Troy School District

**RFP #2425-09 - Addendum #1
BP#2B High School Athletics - Phase #2
January 21st, 2025**

Troy Schools District – RFP #2425-09 BP#2B High School Athletics Renovations - Phase #2

Addendum #1 Bidder Clarifications

DRAWING NO.
LD1.05

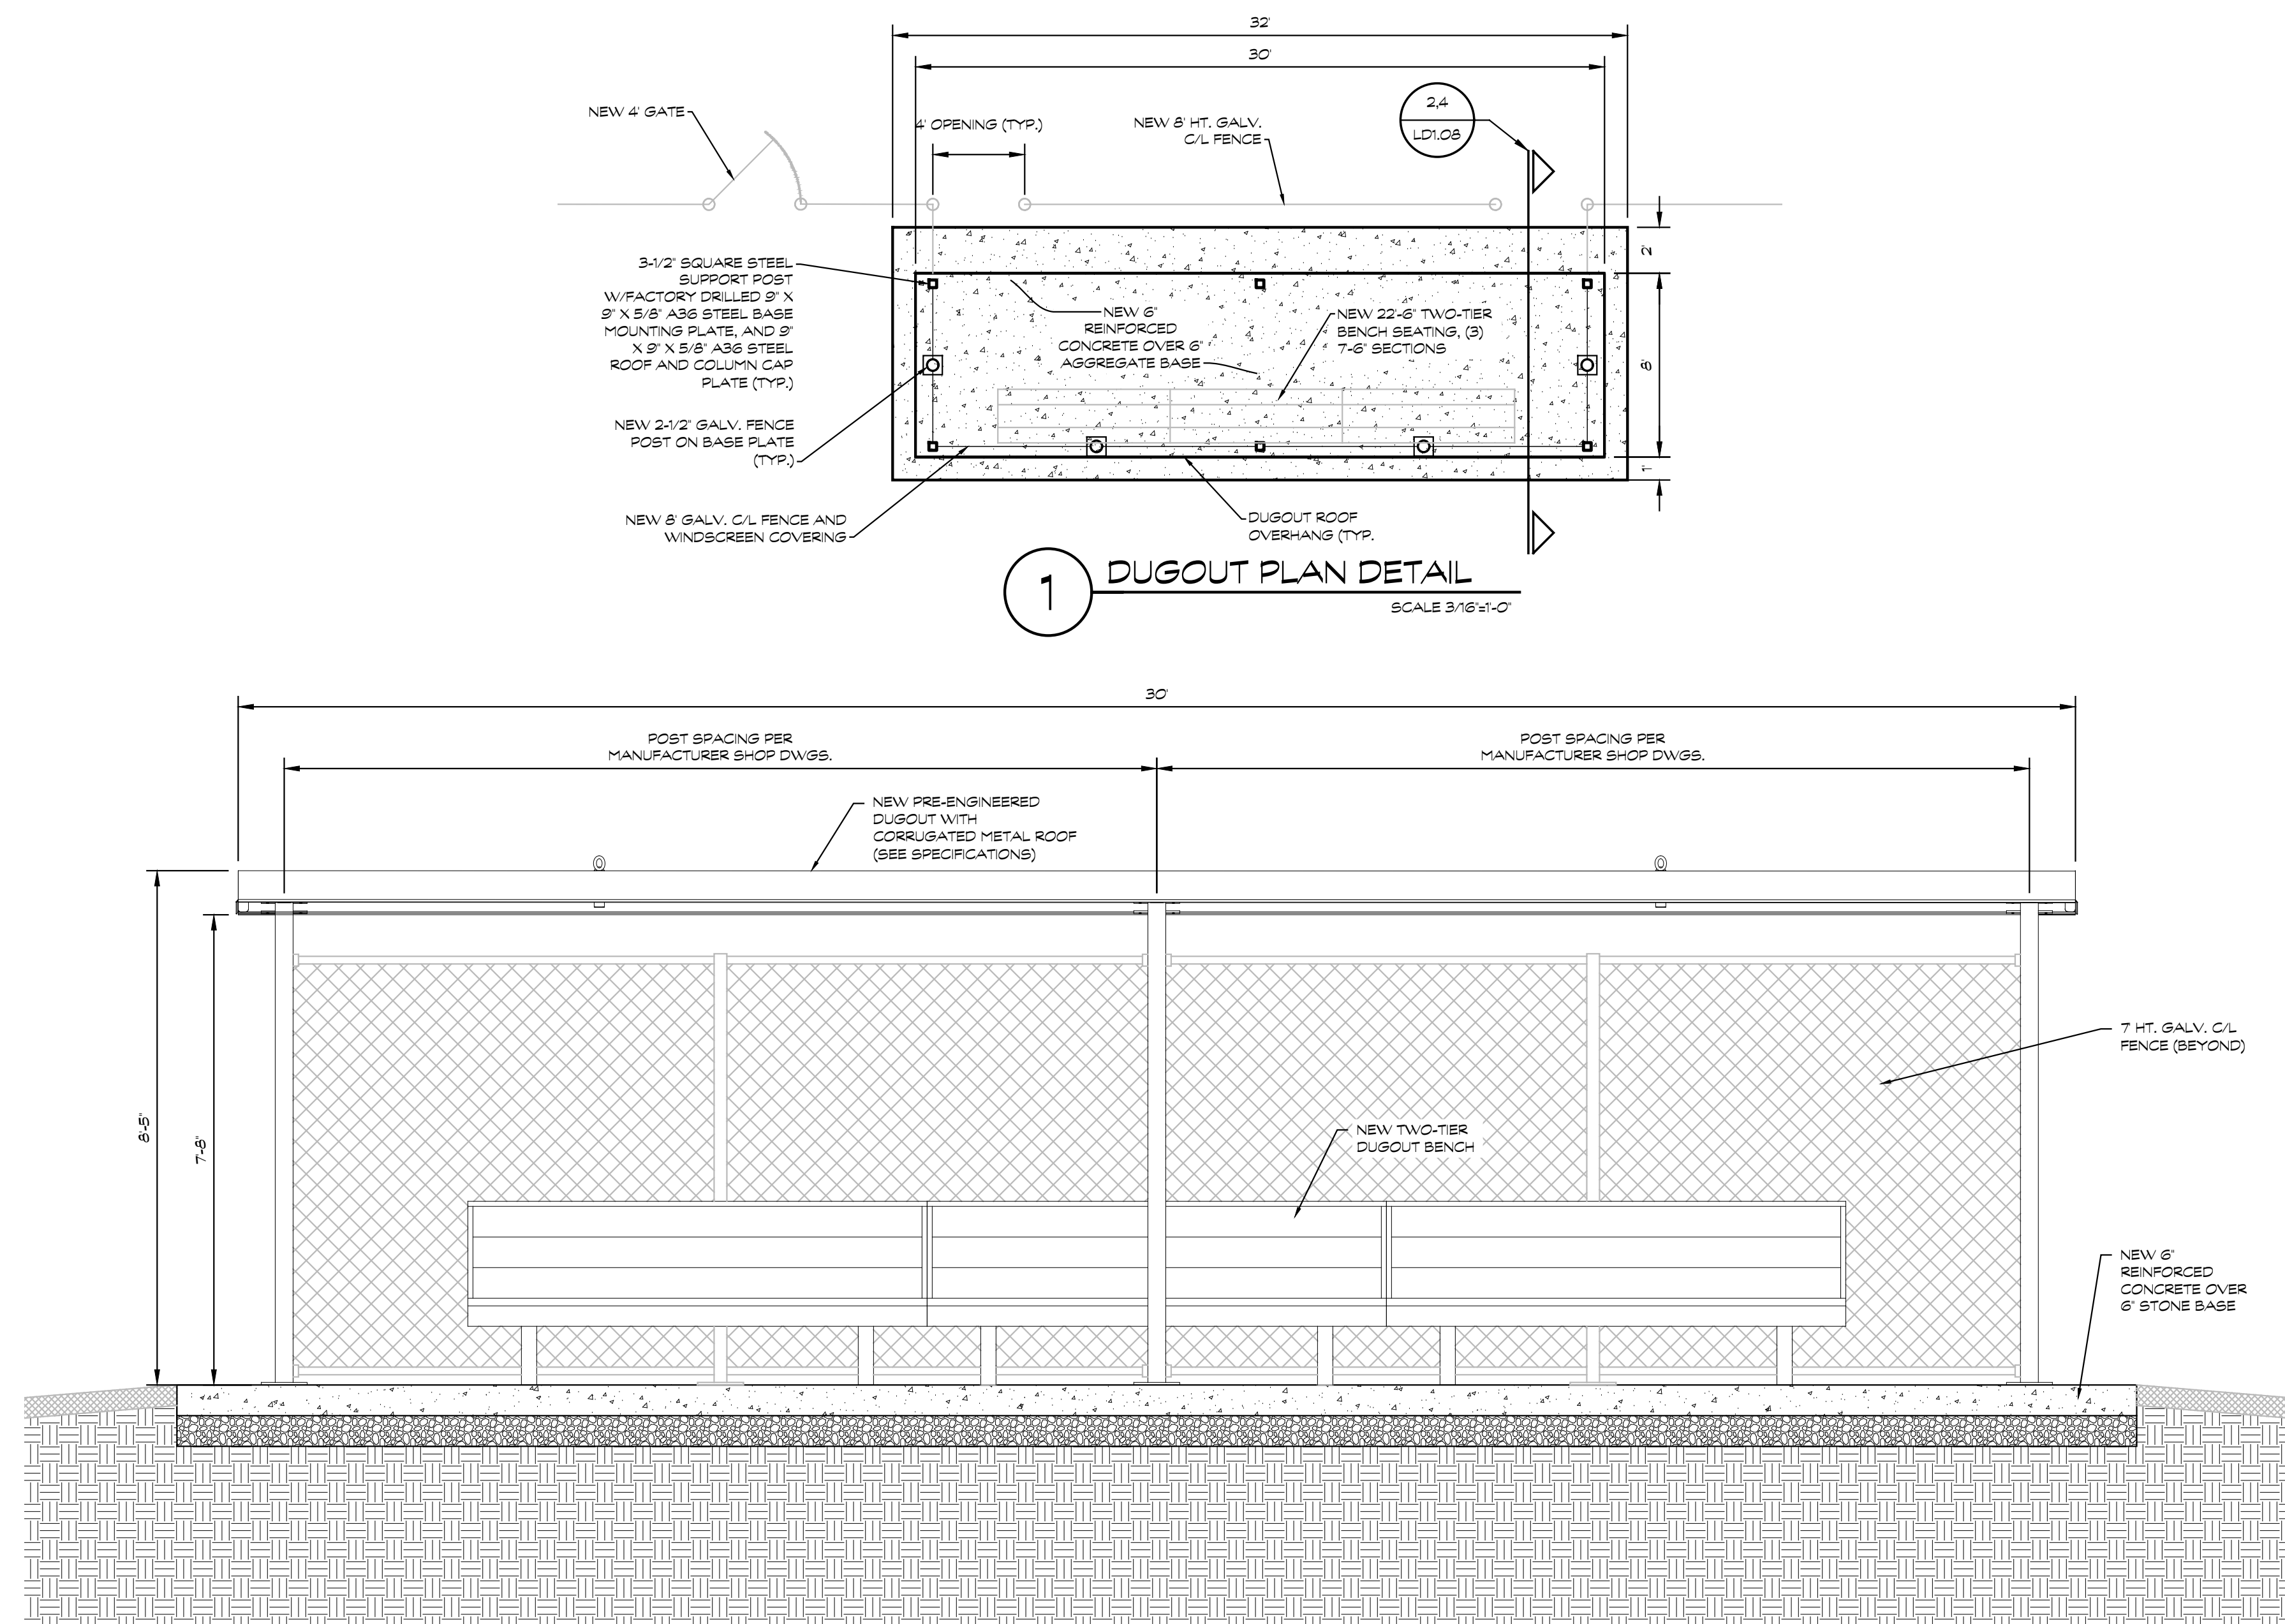
- A. Added note clarifying the intent for post sizes on gates larger than 12' as indicated.
- LD-10 Refer to Drawing No. LD1.08 (reissued):
 - A. Revised details; moved JV dugout details from different LD sheet onto sheet as indicated.

LD1.08

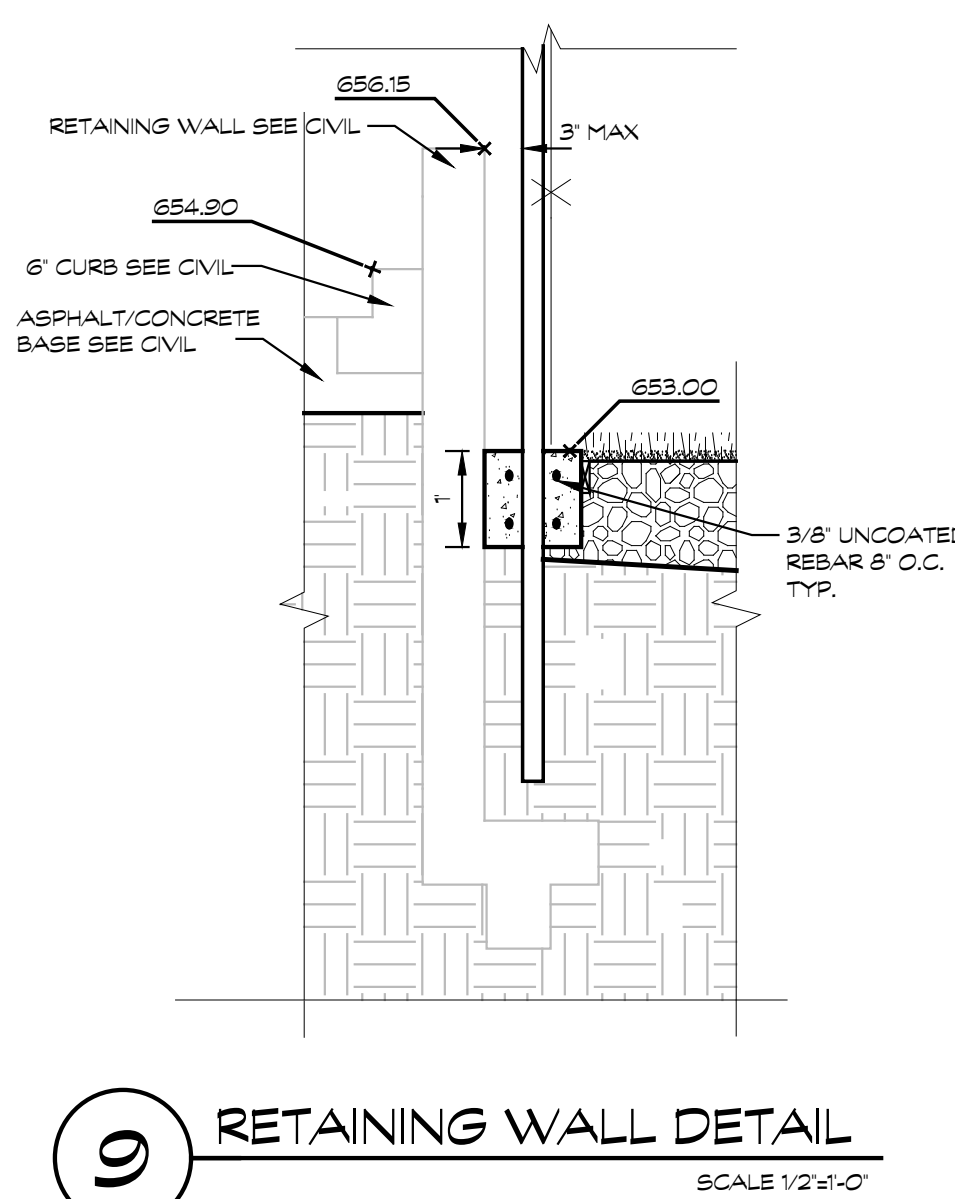
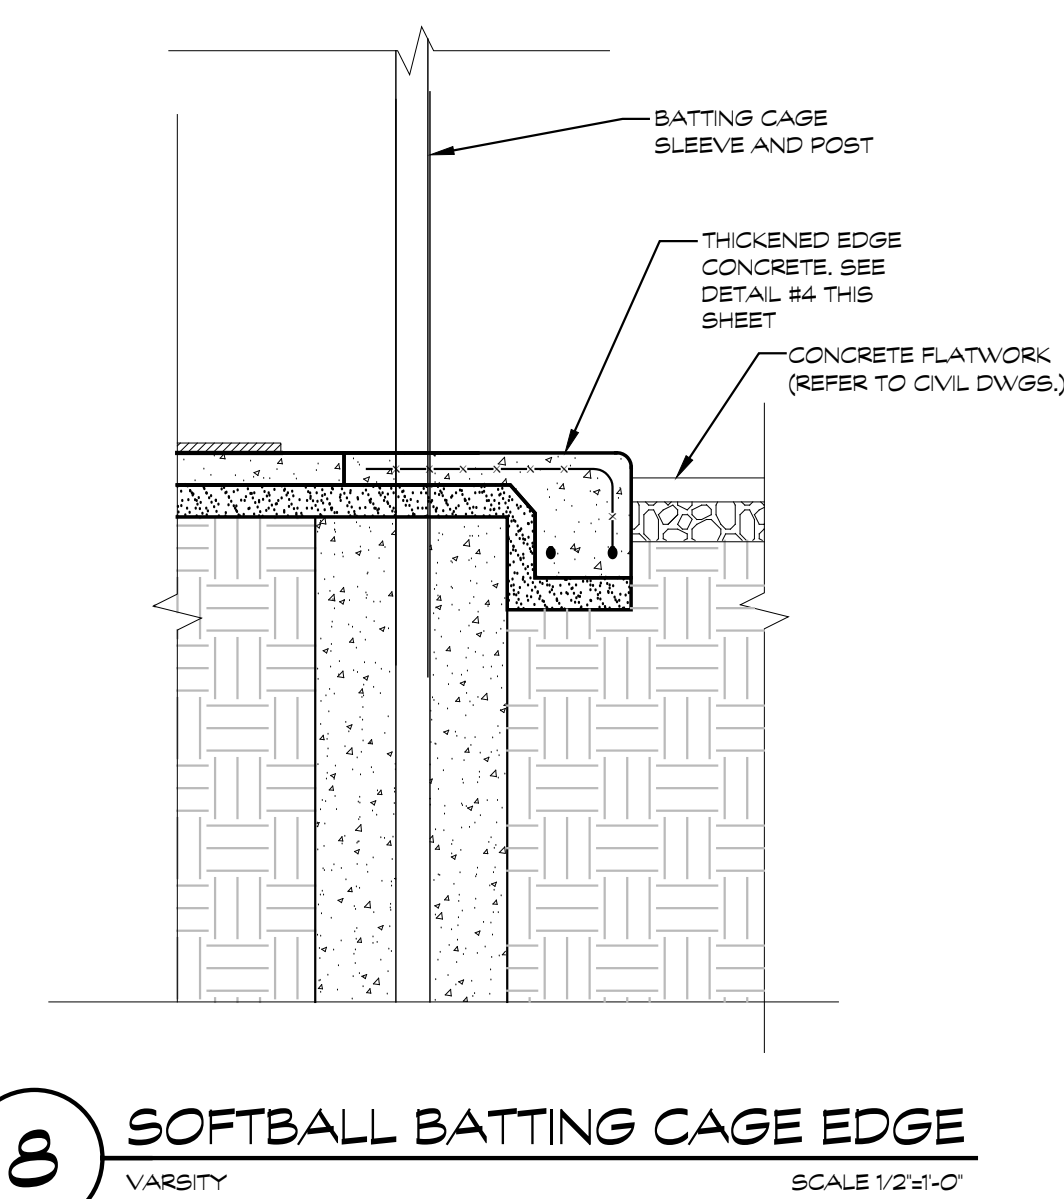
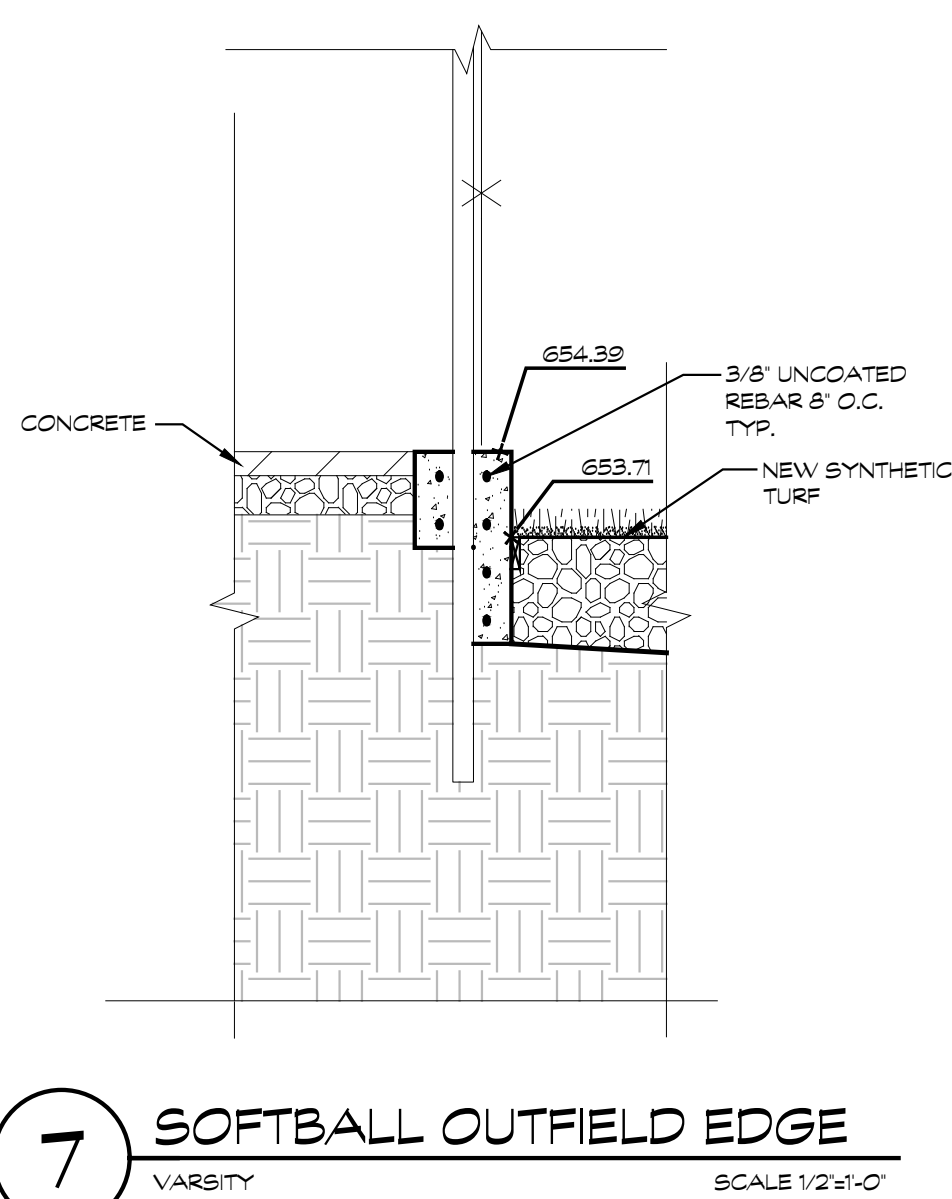
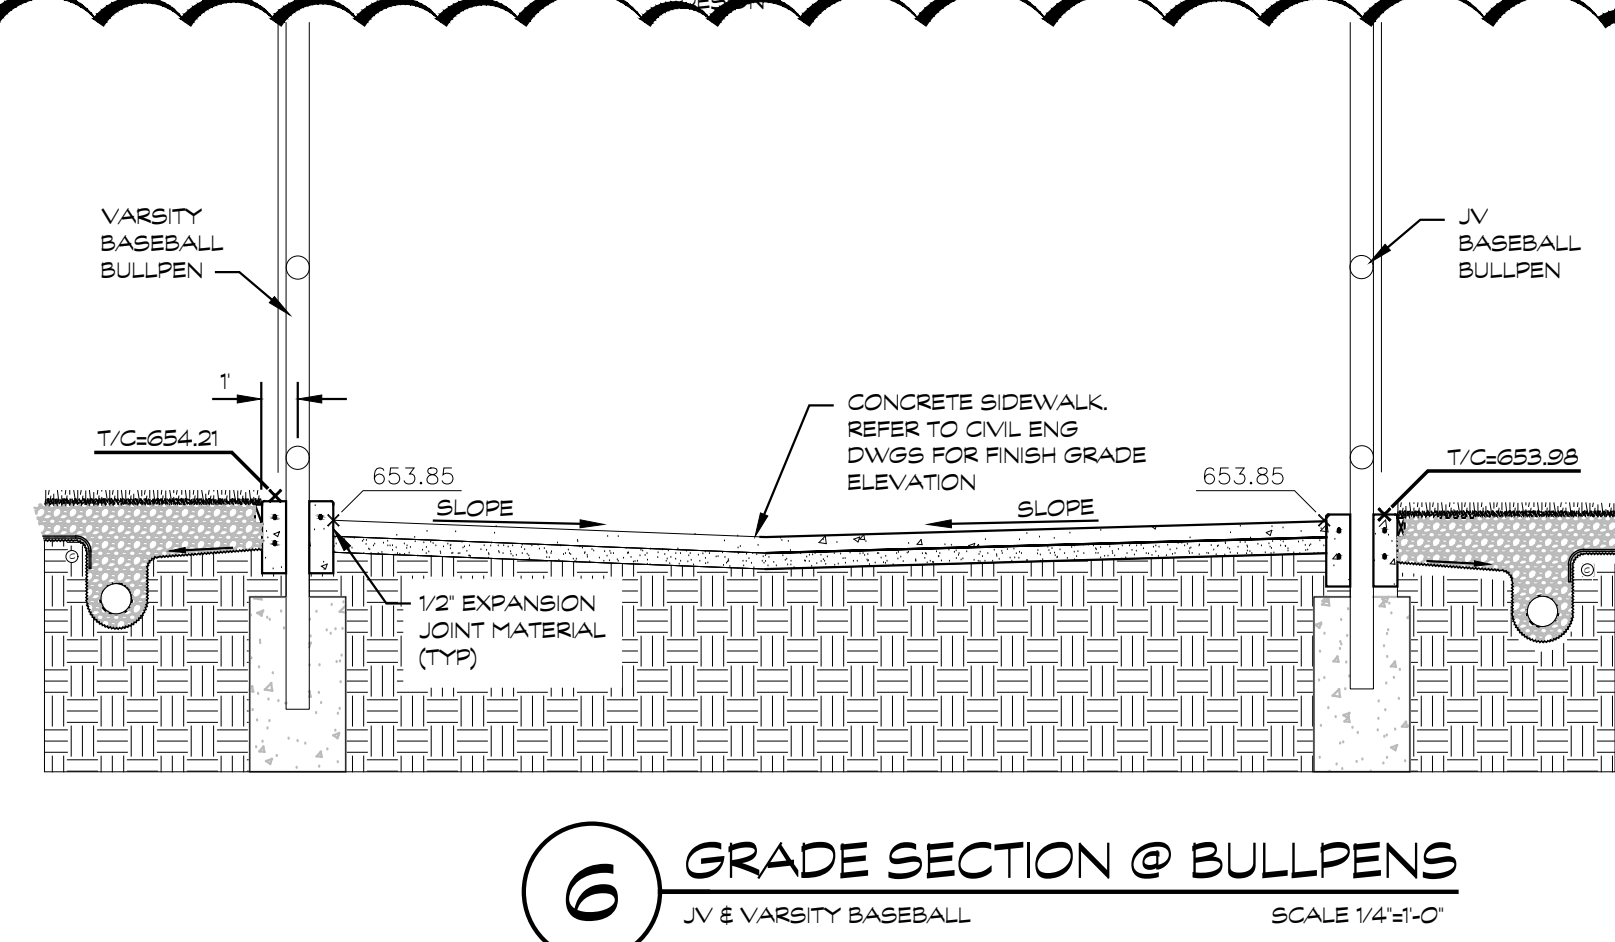
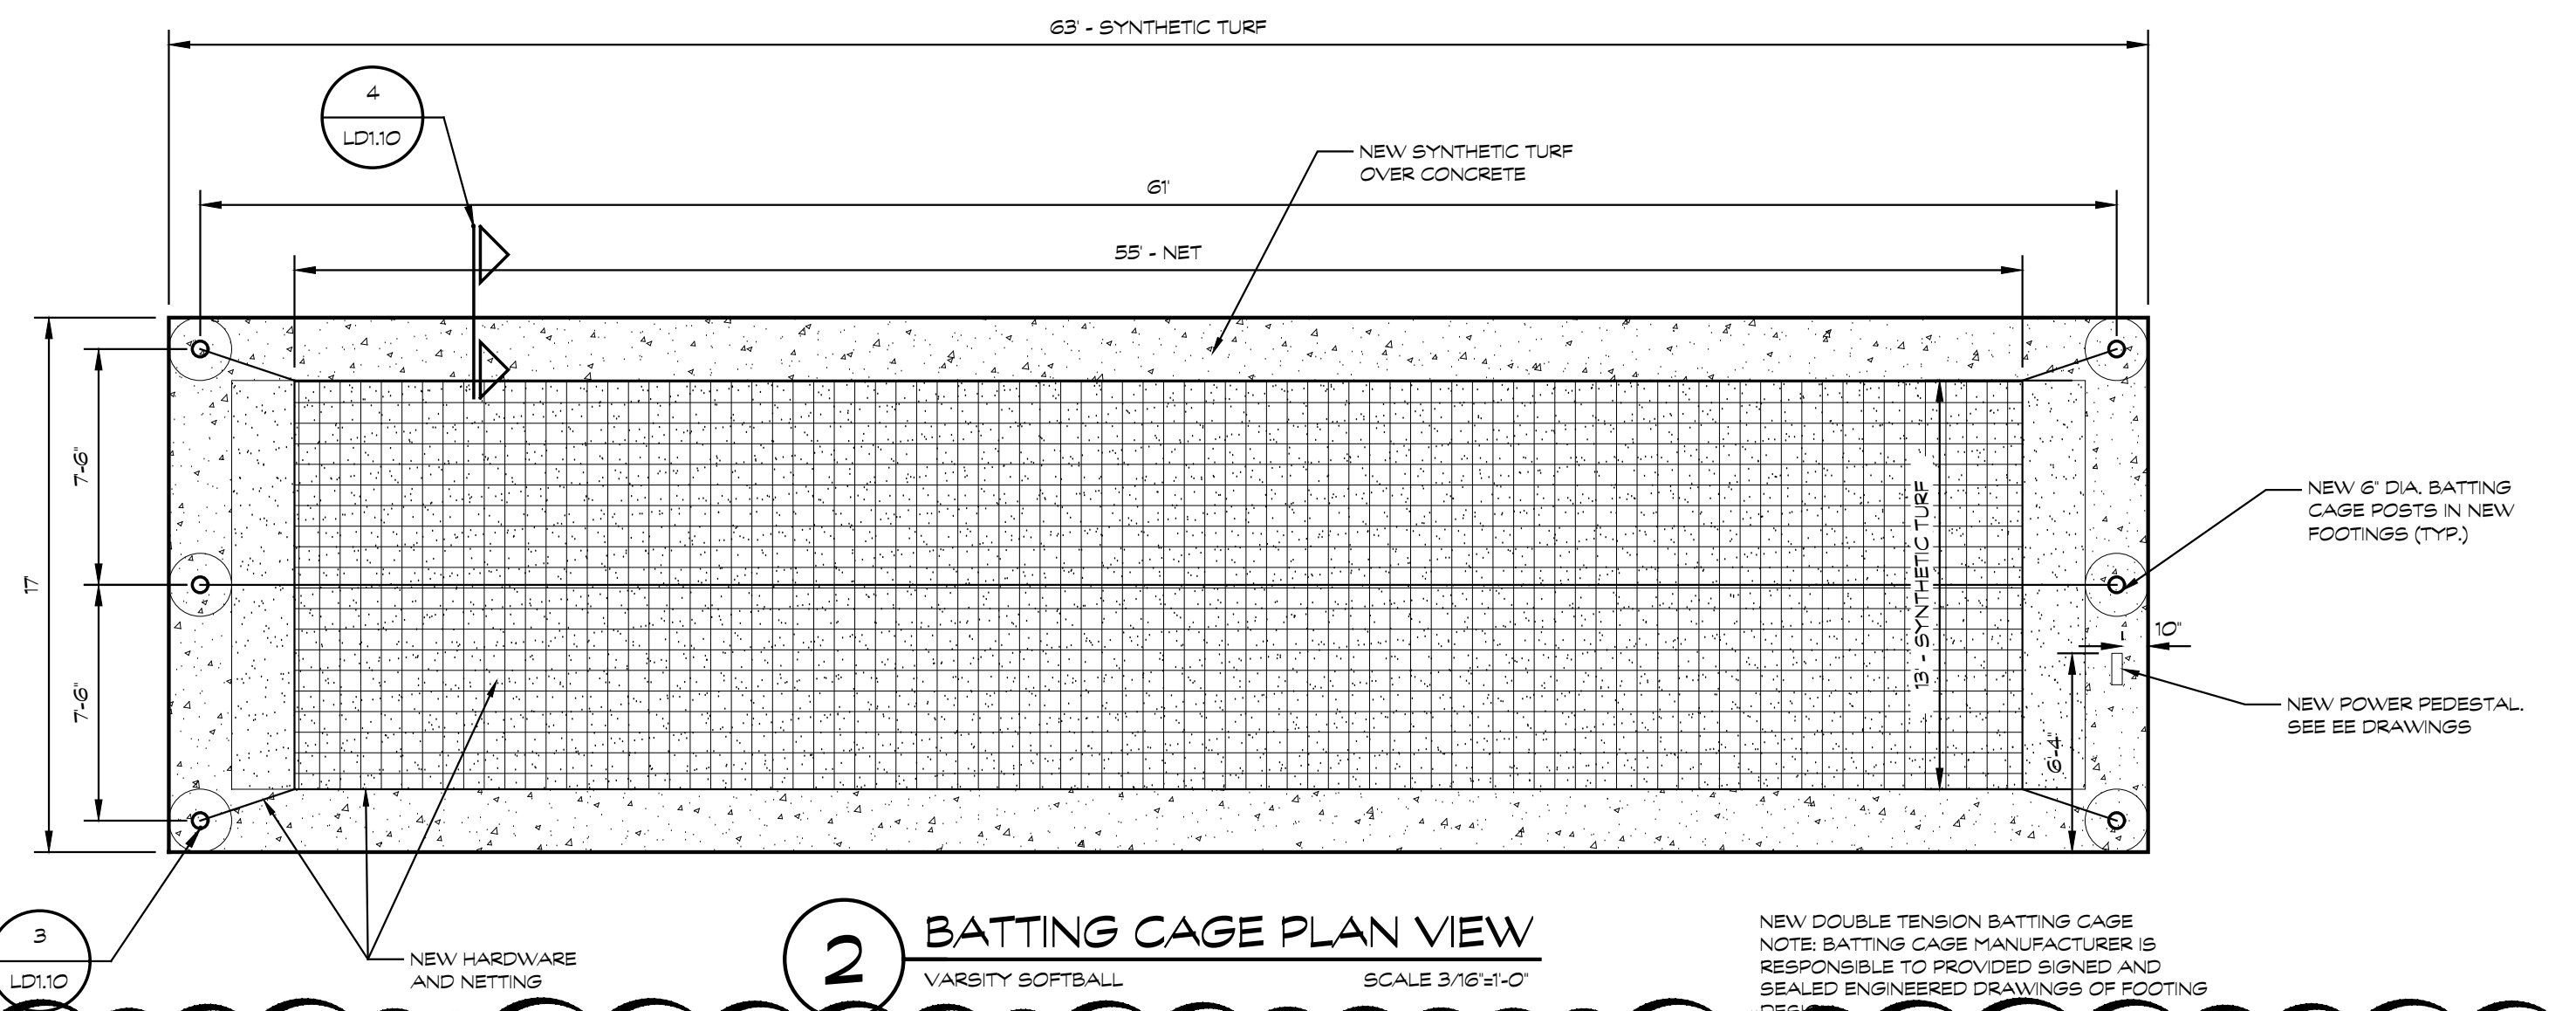
- B. Revised details; backstop detail numbers are reordered as indicated.
- LD-11 Refer to Drawing No. LD1.09 (not reissued):
 - A. Revised bullpen drain tile diameter to 6".
